CONTACTORS, RELAYS, AND TRANSFER SWITCHES
 HAVING NO KS DESIGNATIONS AND
 USED IN ENGINE CONTROL CIRCUITS

1.01 This addendum supplements Section A401.577, Issue 2-D, and replaces Addendum A401.577, Issue 1.

(b) It is reissued to include the equipment used in the control circuits associated with KS-5667 and KS-5750 engine-alternator sets. Changes made in this issue are marked by arrows.

Fig. 13 - Checking Circuit

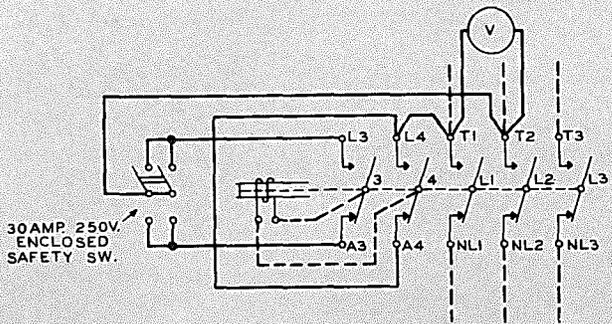
(11) When checking an Automatic Switch
Company's Transfer Switch, Bul 905,
Bul 907 or Bul 908, operate the BY PASS
switch to the NORMAL LINE TO LOAD position.
Disconnect and tape the leads at terminals
L3, L4, A3, and A4. Set up the checking
circuit shown in Fig. 13 using wire of the
sizes specified below. The operating coil
is designed for momentary duty only and
for that reason the contactor should not
be operated more often than once per
minute.

<u>Capacity of Transfer Switch</u> <u>Amperes</u>	<u>Wire Size</u> <u>Minimum</u>
100	#14
150	#12
200	#8
300	#8

Fig. 14 - Automatic Switch Compaany Transfer
Switch Cat. 119S8C

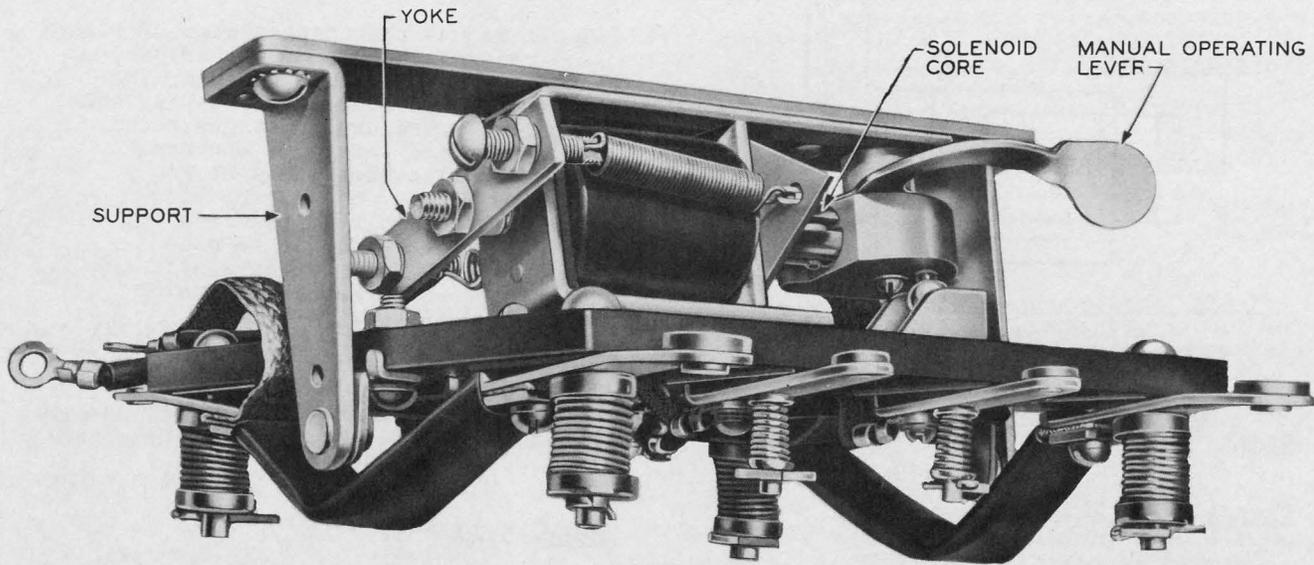
*3.13 Automatic Switch Company
Cat. 11958C Transfer
Switch

(1) The stationary contacts are adjustable by rotating them, as required, on their supporting studs. Connect the 81A test set to the pair of contacts being checked. Obtain partial operation of the switch by slowly moving the manual operating lever in the required direction. With the steel scale held

against the support, with its end against the yoke, observe the travel of the core, to which the yoke is attached, at the moment the contacts break.

Adjust the stationary contact as required. See Fig. 13, which shows the operating mechanism and movable contact assembly, omitting the stationary contacts.

*2.13 Automatic Switch Company, Cat.
119S8C Transfer Switch: The auxi-
liary contacts shall be adjusted to break
when the solenoid core has moved from
its normal position.

Minimum 1/4"
Maximum 5/16"
